GALLOWAY RESPONSE

CALAMAR 55+ AT STERLING HILLS - SITE PLAN

LOT 1, BLOCK 1, STERLING HILLS SUBDIVISION FILING NO. 14

SOUTH BUILDING ELEVATIONS -
MINOR BUILDING FACE

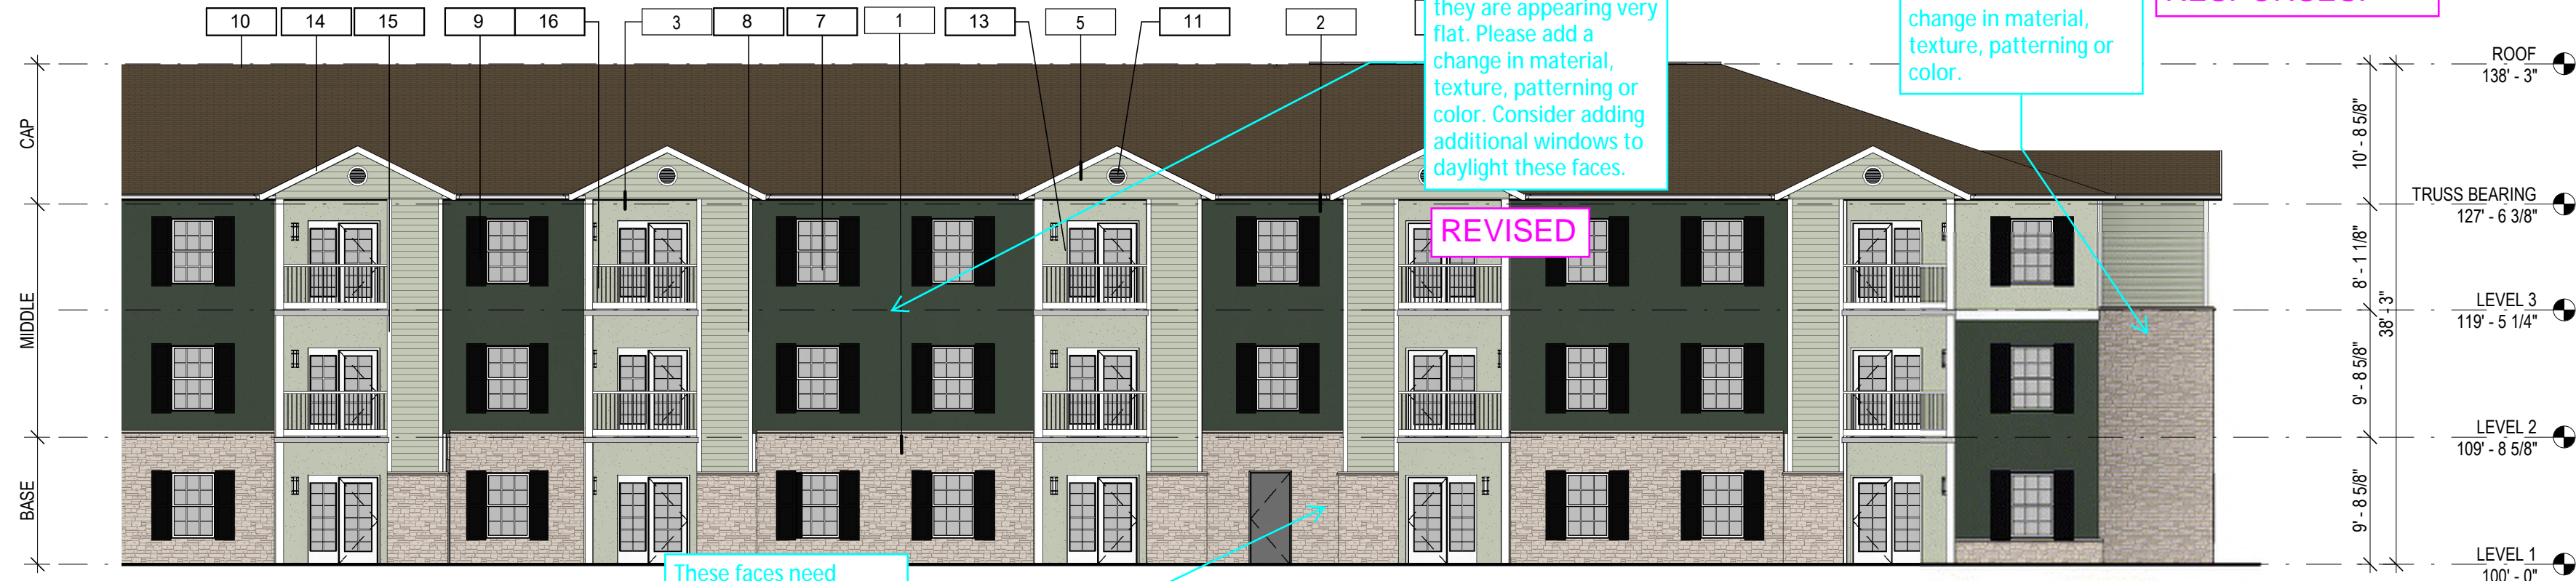
Please refer to section 146-4.8.5 for massing guidance on all elevations; Contact the Case Planner with any questions. All elevation comments apply to all elevations and faces.

1 NORTH ELEVATION 1 - PRIMARY BUILDING FACE
SCALE: 3/32" = 1'-0"

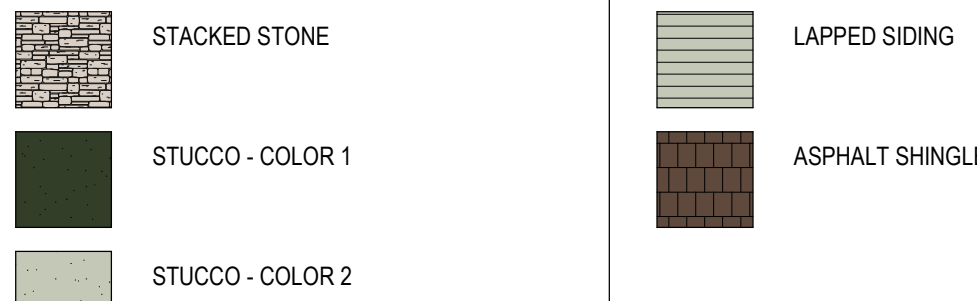
These faces need additional dimension; they are appearing very flat. Please add a change in material, texture, patterning or color.

These faces need additional dimension; they are appearing very flat. Please add a change in material, texture, patterning or color.

REVISED

Re: **Calamar 55+ At Sterling
Traffic Memorandum**

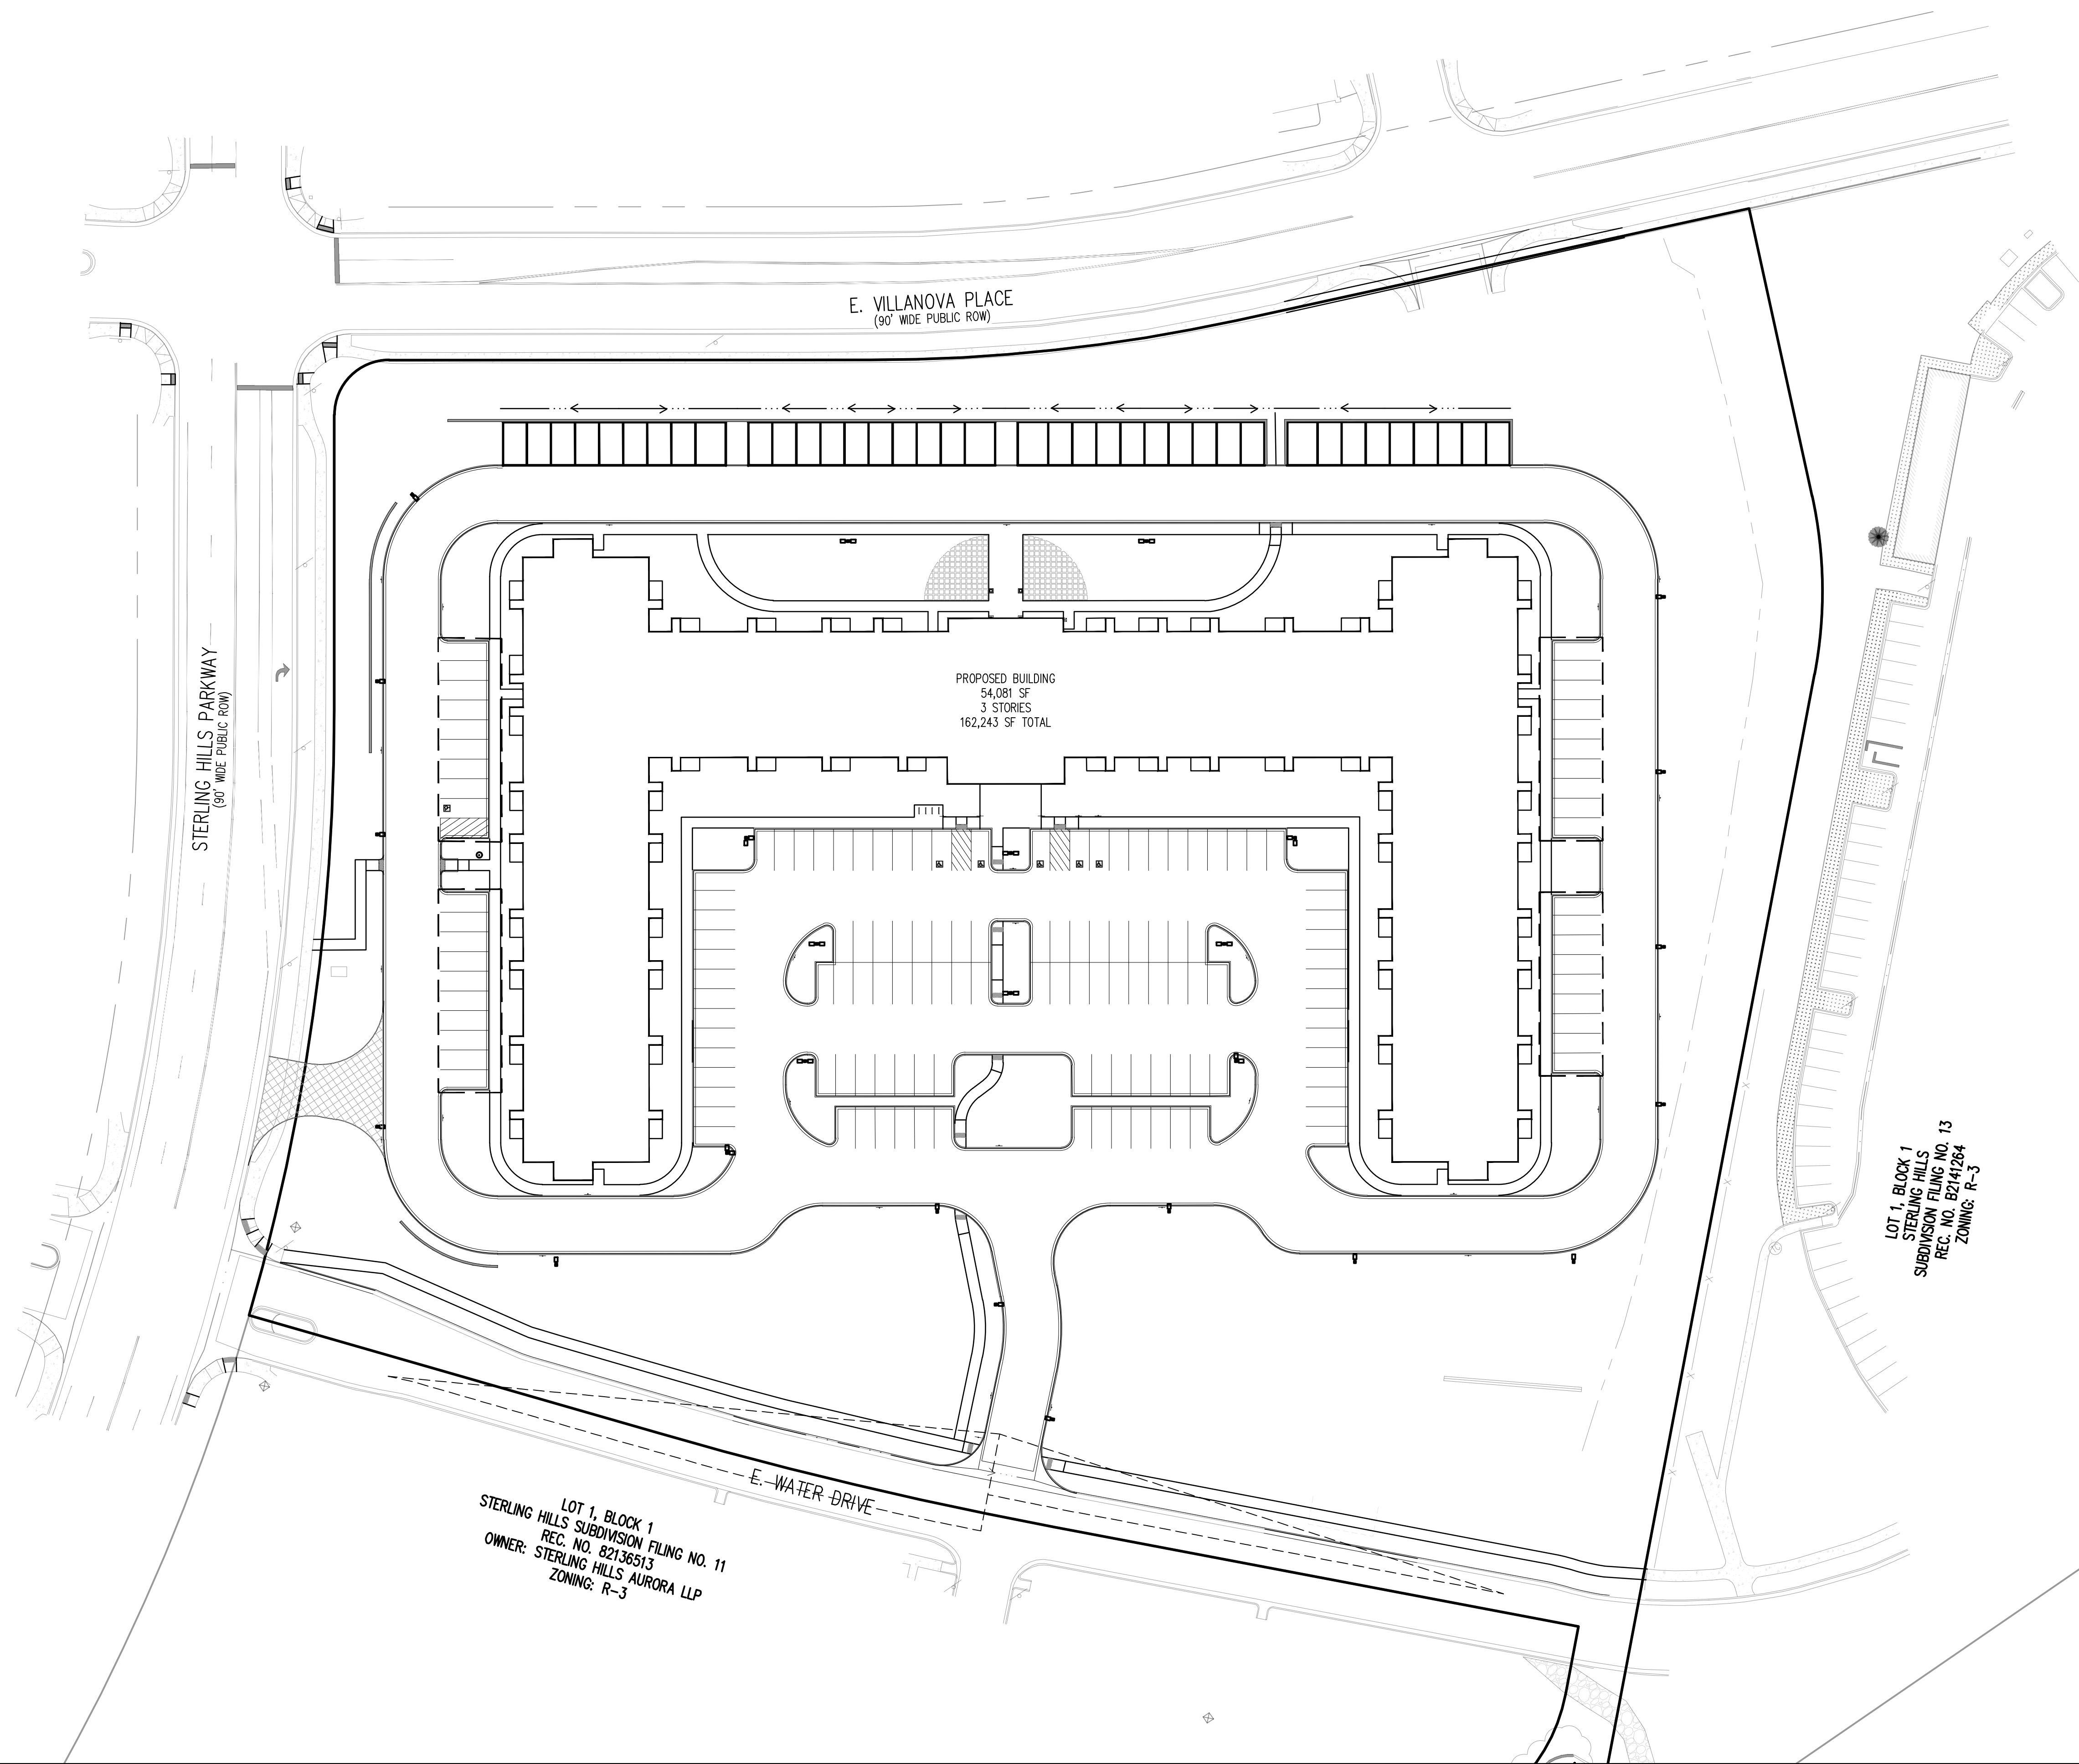
add ADT rate

ADT rate added in up-
dated Traffic memo

Addressed in updated
Traffic memo
